ADDENDUM NO. 1

JOB NO. F80C661C
KALALAU TRAIL ROCKFALL MITIGATION
NAPALI COAST STATE WILDERNESS PARK, KAUAI, HAWAII

April 28, 2016

SITE 2 – SCULPTED SHOTCRETE PEDESTAL DETAIL
 NOT TO SCALE

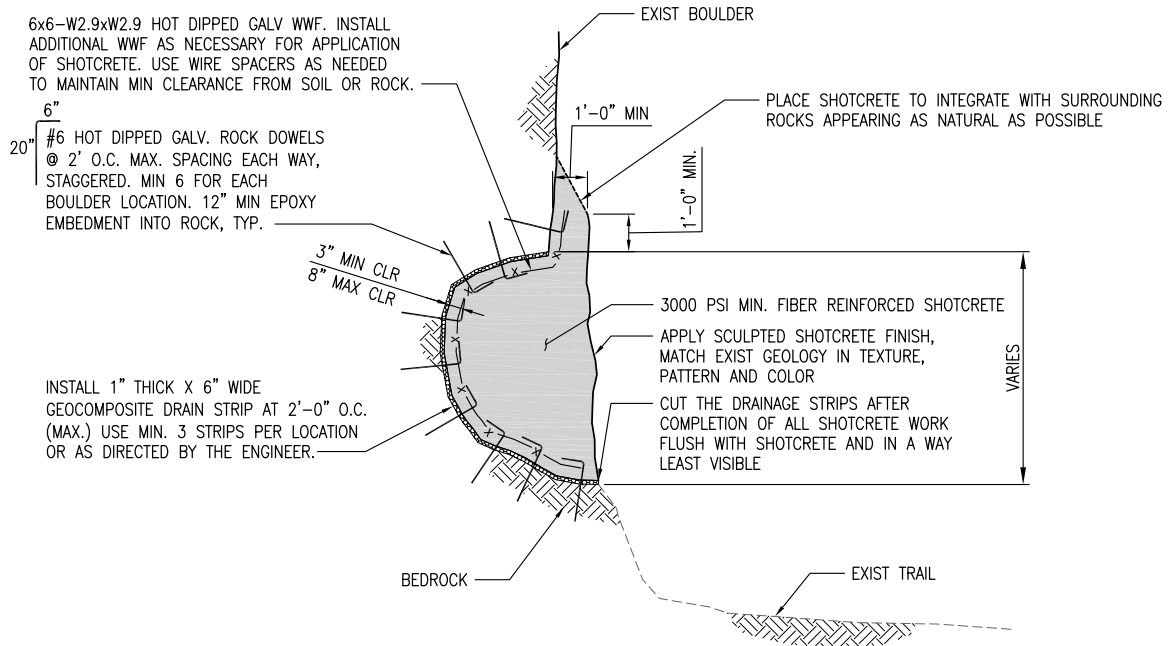
- Revise detail for the shotcrete pedestal at Site 2.
 - *A 1'x1' shotcrete lip shall be installed along the bottom of the entire width of the boulder. Additional steel reinforcing mesh shall also be required, see attached detail Sketch No. 1.*

BOULDER 3
 APPROXIMATE LIMITS OF SHOTCRETE

BOULDER 3 SUMMARY:
 APPROXIMATE SHOTCRETE AREA DIMENSIONS:
 HEIGHT = 5.0'
 WIDTH = 6.0'
 DEPTH = 4.0'
